PCN-20210219 TE0745-02 DDR3 Change and Product Update

Company	Trenz Electronic GmbH
PCN Number	PCN-20210219
Title	TE0745-02 DDR3 Change and Product Update
Subject	BOM change
Issue Date	2021-03-09

This change affects all Trenz Electronic TE0745 SoMs of revision 02: TE0745-02-*

#4 Set S/N to not fitted

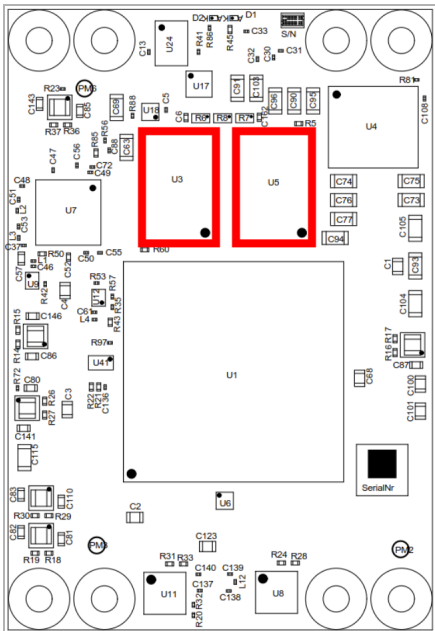
Type: BOM change

Reason: Part is end of life.

Impact: Track it pad no more available. Pin 20 of CPLD was connected via S/N to GND and is now floating. However pin is not used in delivery CPLD Firmware, so no further impact.
